**COPIES OF CORRESPONDENCE AND
PREVIOUSLY-ISSUED FAA AERONAUTICAL
STUDIES
(DETERMINATIONS OF NO HAZARD)
IESI TRAVIS COUNTY LANDFILL**

SUBJECT: IESI Travis County Landfill (revised)
9600 FM 812
Austin, TX 78719-9734
Case No. SP-2018-XXXX

**Subject: IESI Travis County Landfill
Permit application
Lateral expansion**

Additional information for ASN 2007-ASW-9276-OE

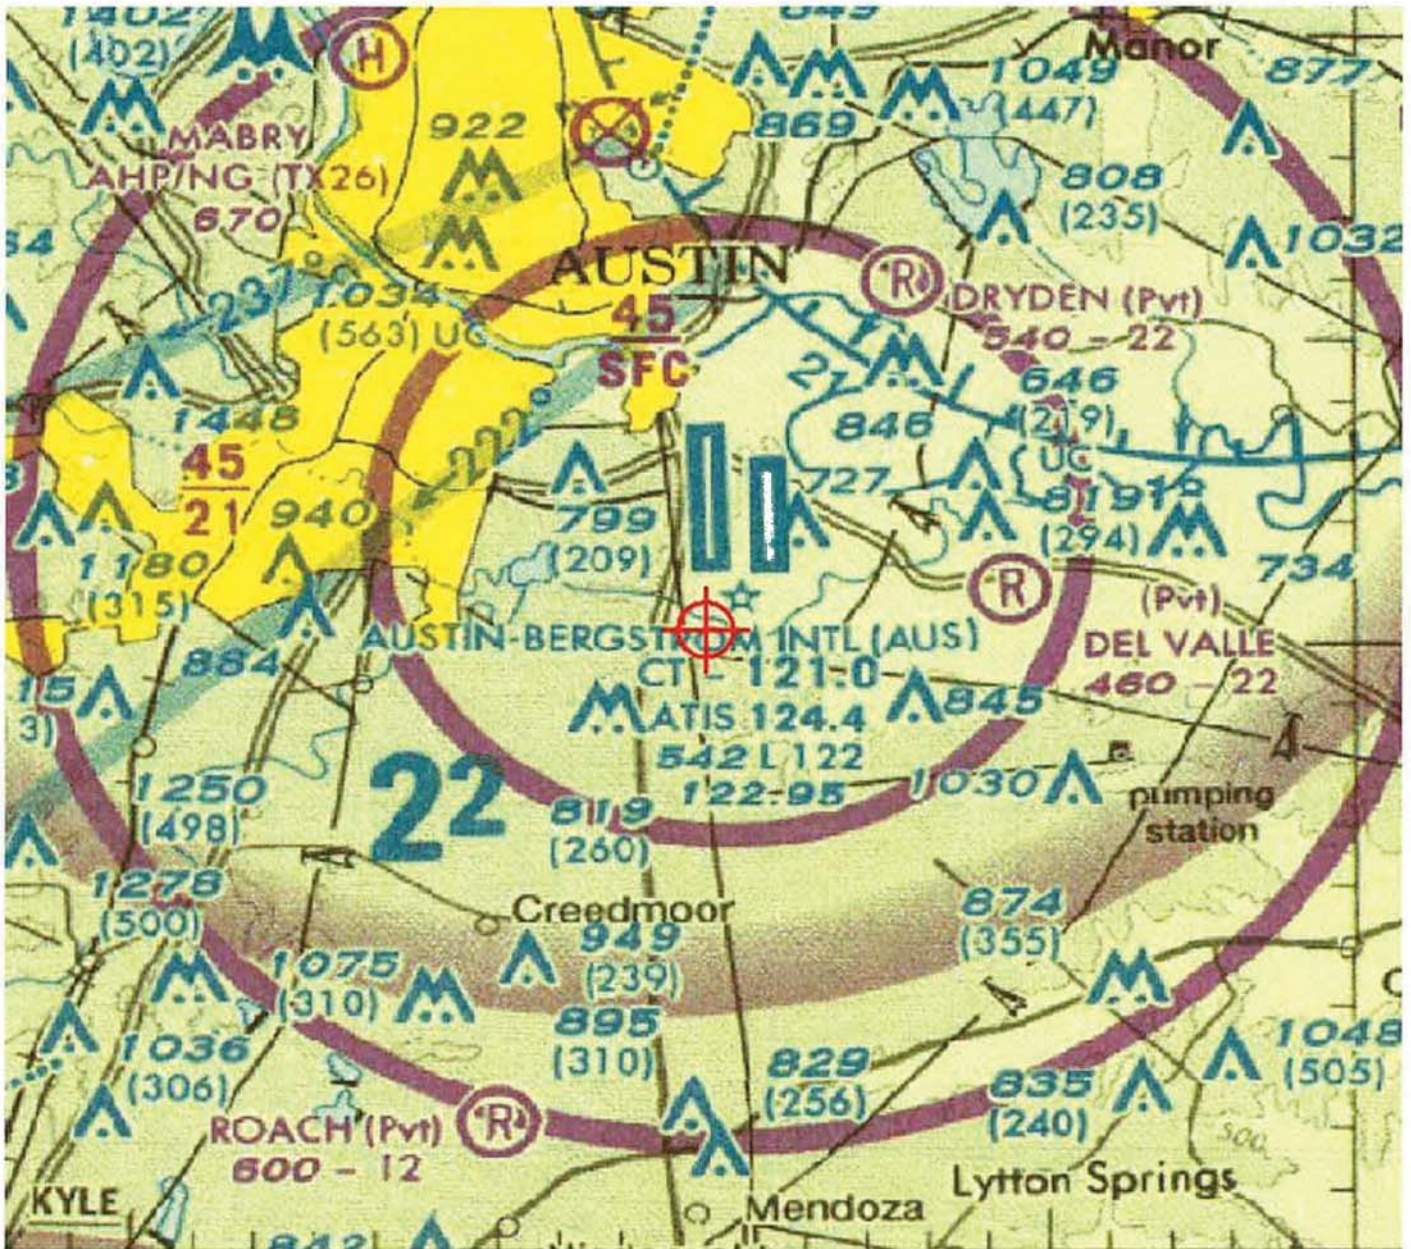
The landfill itself does not exceed any obstruction standards contained in 14 CFR Part 77. Standards are exceeded only when the 15-foot equipment is added into the equation.

This determination includes the maximum height of the landfill, plus the use of 15-foot equipment. When the equipment is working at the maximum height of the landfill, all equipment shall be obstruction flagged during daytime hours. All equipment shall be removed from the highest point of the landfill at night.

Additional information for ASN 2007-ASW-9277-OE

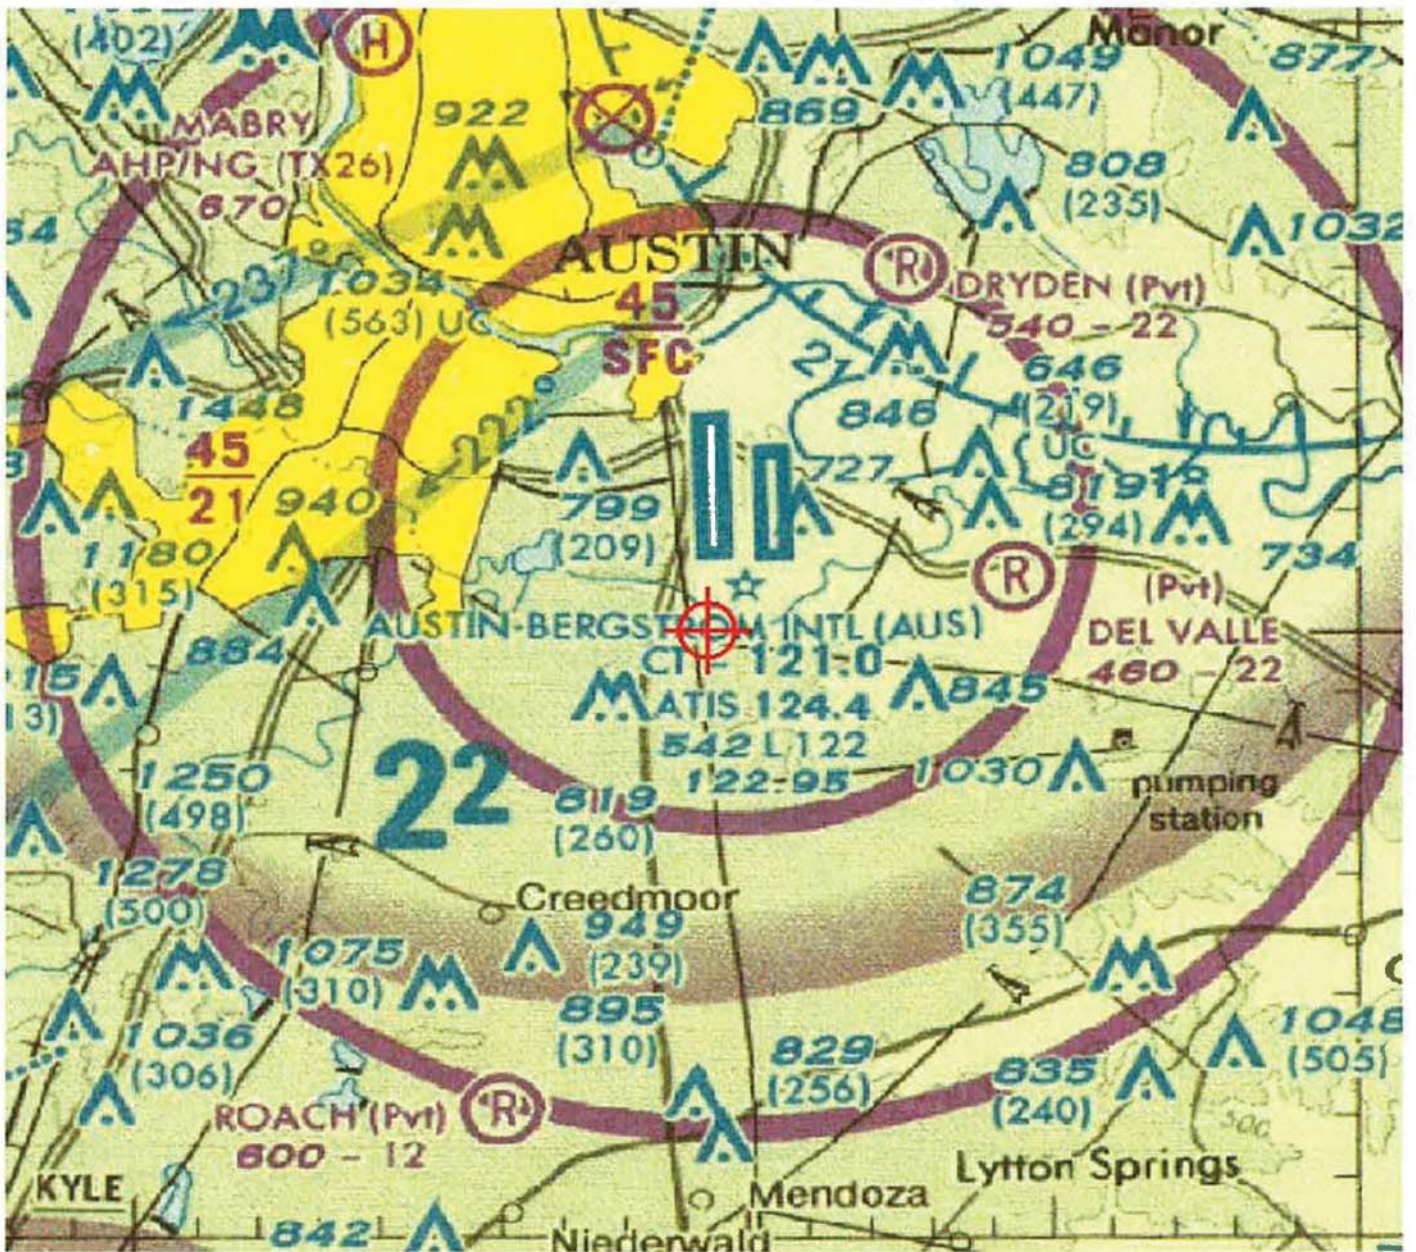
The landfill itself does not exceed any obstruction standards contained in 14 CFR Part 77. Standards are exceeded only when the 15-foot equipment is added into the equation.

This determination includes the maximum height of the landfill, plus the use of 15-foot equipment. When the equipment is working at the maximum height of the landfill, all equipment shall be obstruction flagged during daytime hours. All equipment shall be removed from the highest point of the landfill at night.
